TECHNICAL SERVICE BULLETIN

Dodge Truck Adapter Harness

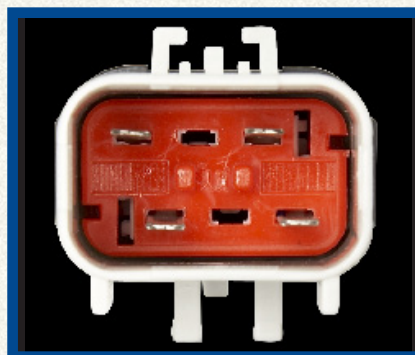
Certain Fuel Pump Assemblies that fit Dodge trucks applications (1996-1997) have an adapter harness included with the replacement assembly to plug into the original vehicle wiring harness.

The replacement adapter harness has a 4-pin connector when compared to the original Fuel Pump Assembly that is a 6-pin connector. Although the original Fuel Pump Assembly only uses 4 of the 6 pins in the connector.

The replacement adapter harness and the OE vehicle harness differ in appearance; although will perform to OE fit, form and specification.
